Kewaunee Nuclear Power Plant  
Operated by Nuclear Management Company, LLC

Emergency Plan Revision 27

## **ENCLOSURE 1**

### **DESCRIPTION OF CHANGES AND EFFECTIVENESS EVALUATION**

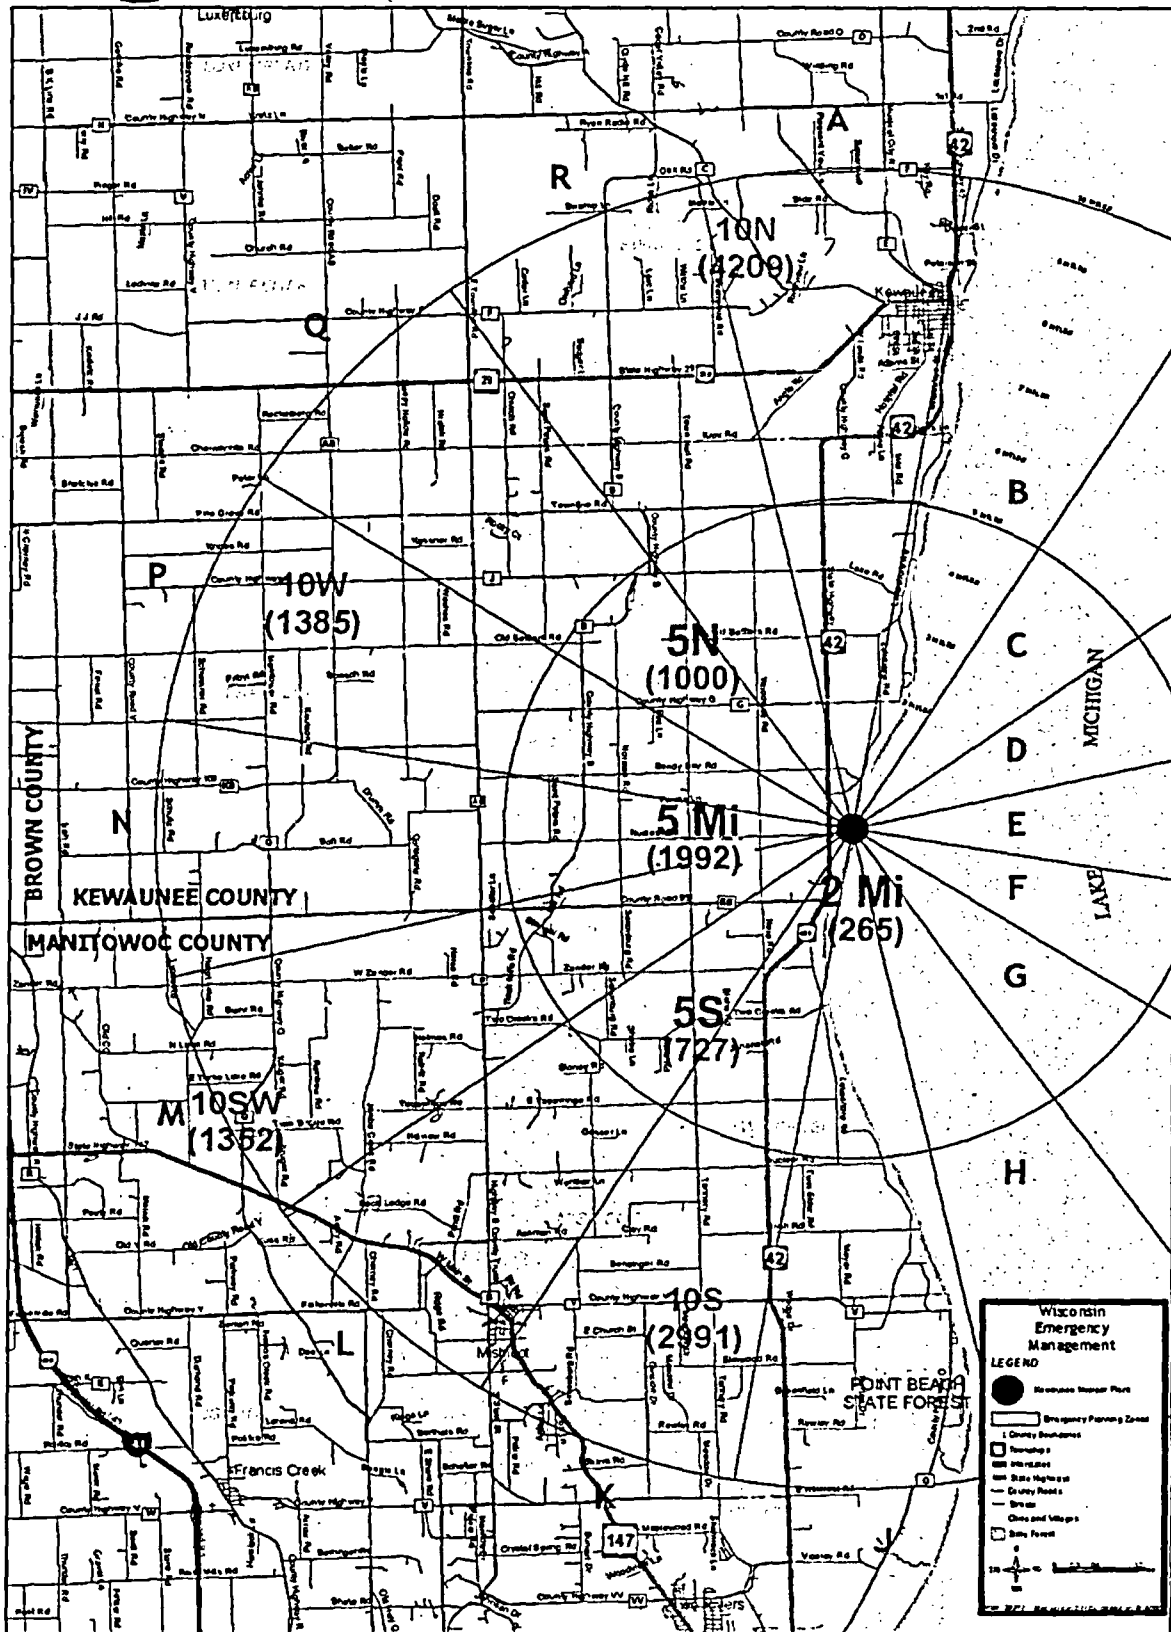
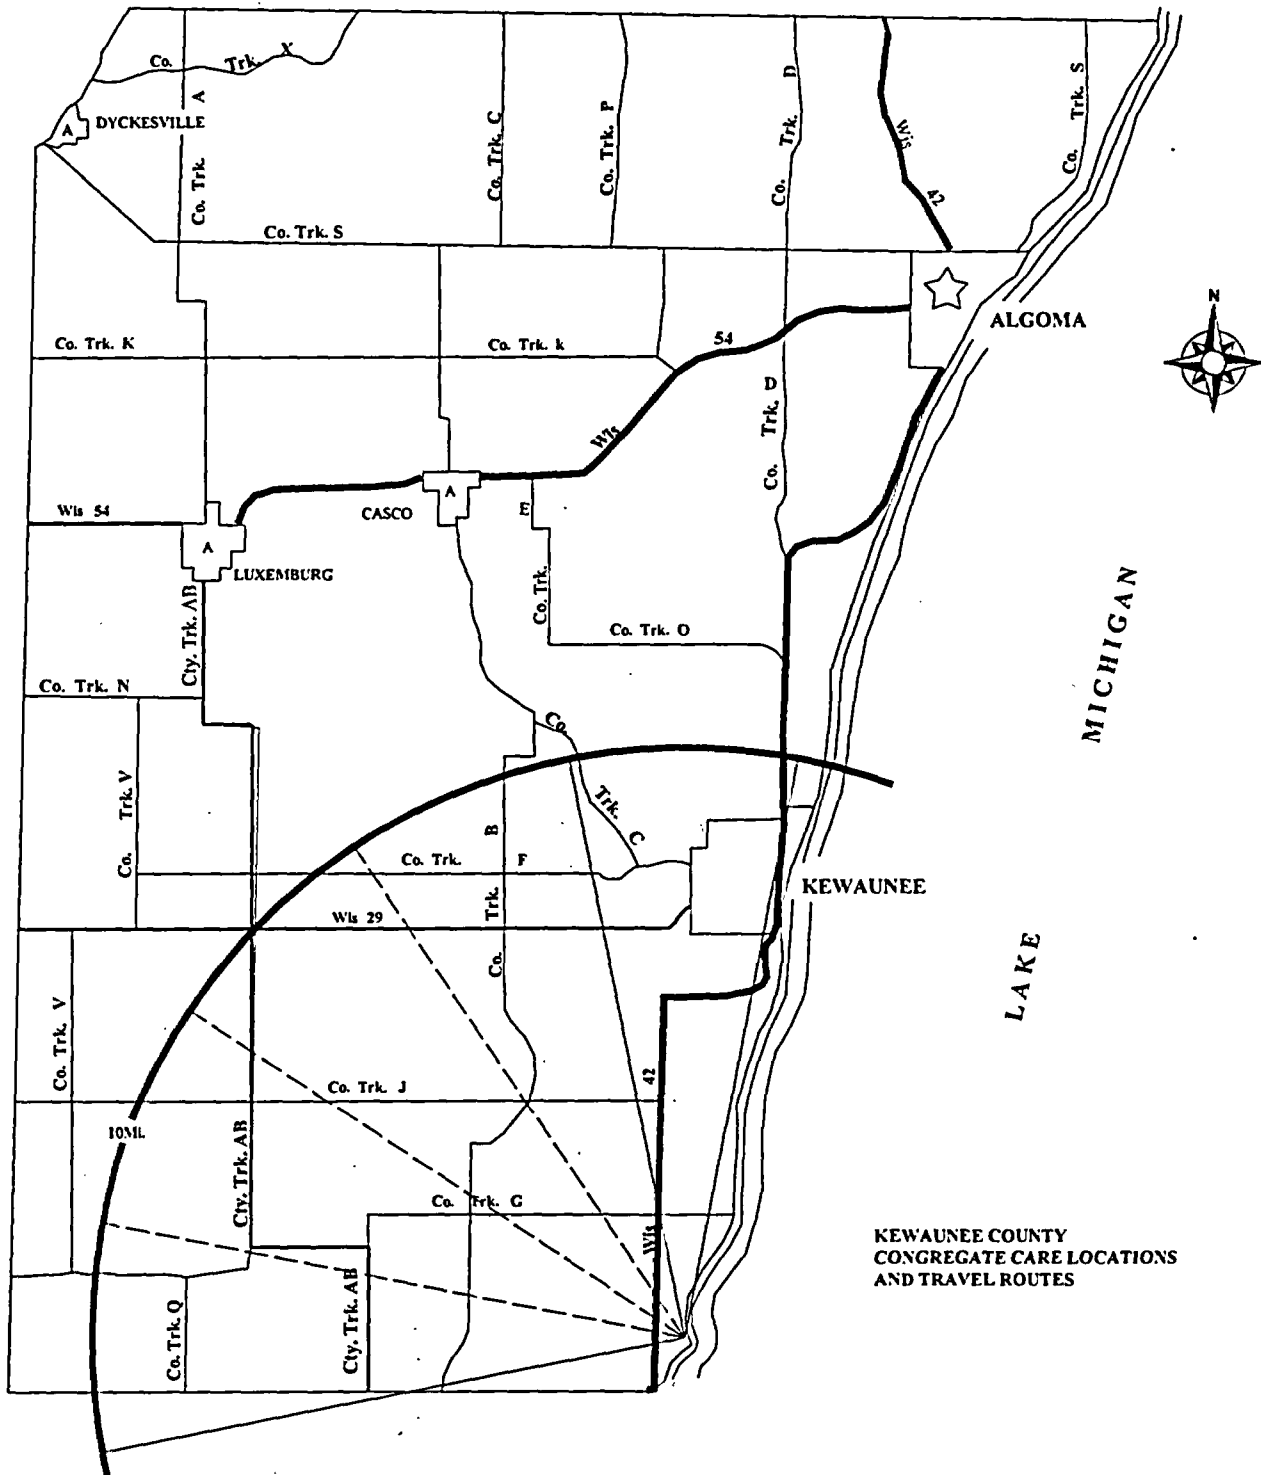
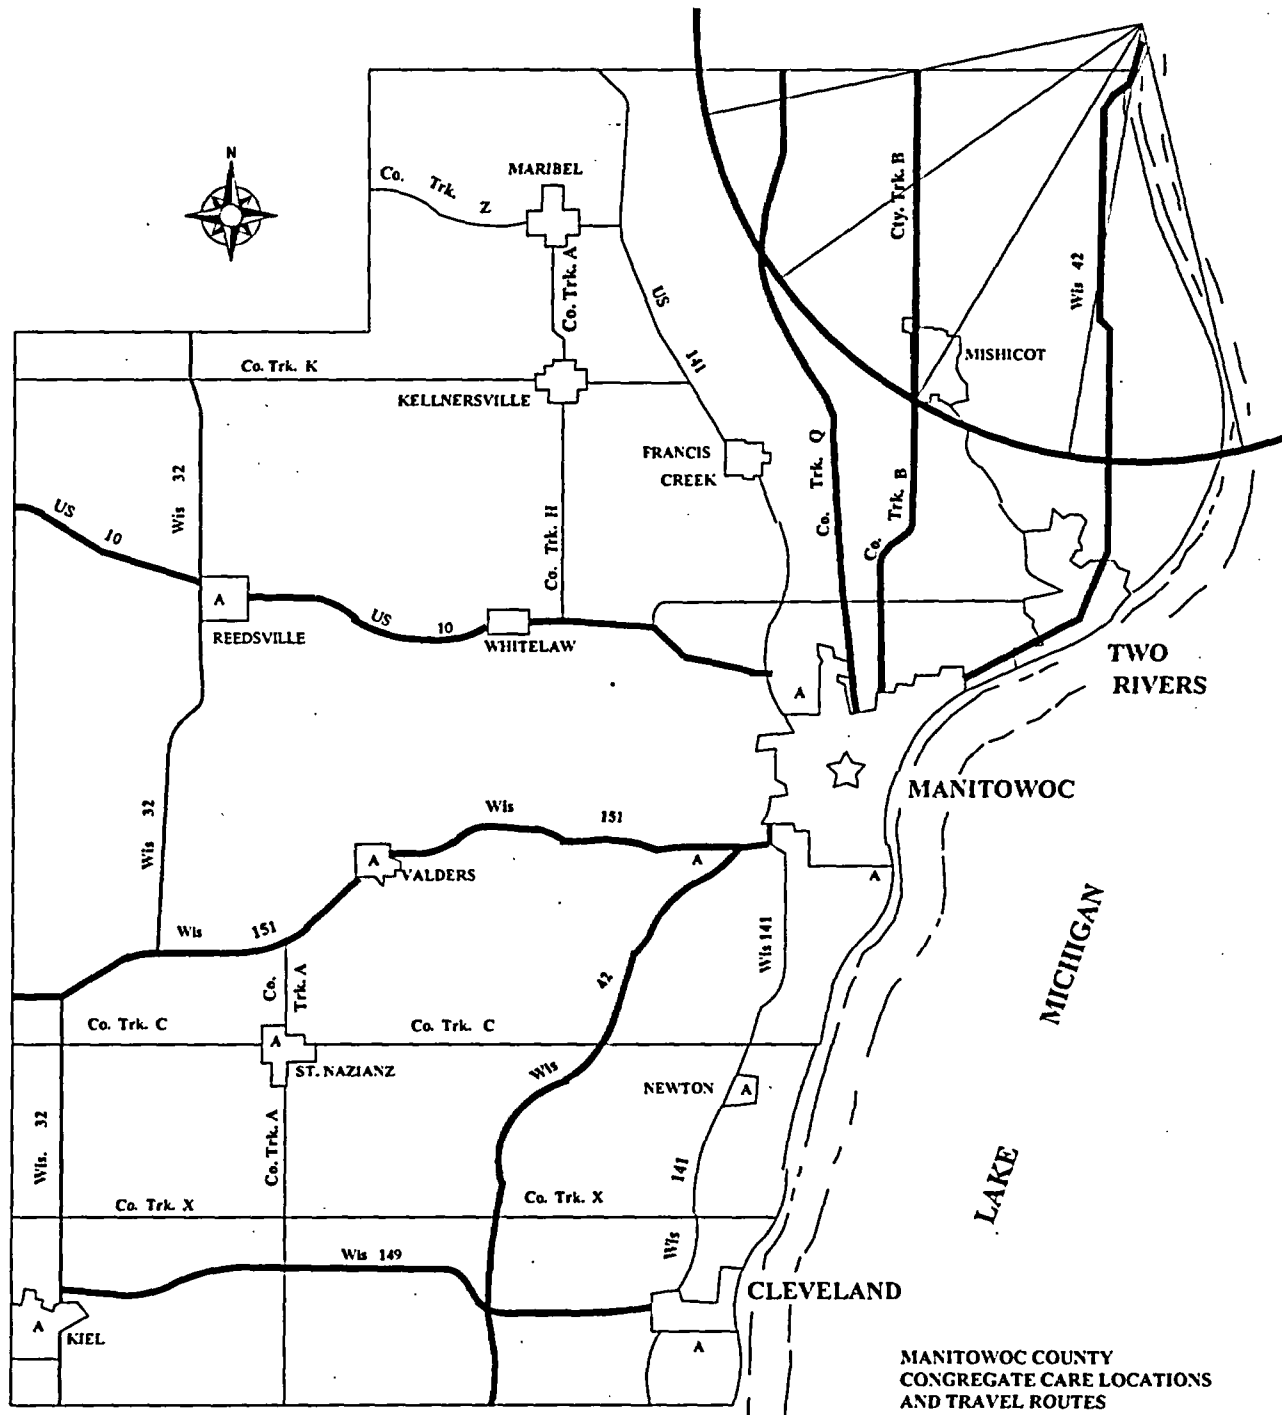
Appendix H			Updated EPZ map and ETE tables.	New data from 2000 census	A new ETE was completed based on 2000 census and any changes in roads which occurred since last ETE study  This change does not reduce effectiveness of the Emergency Plan.
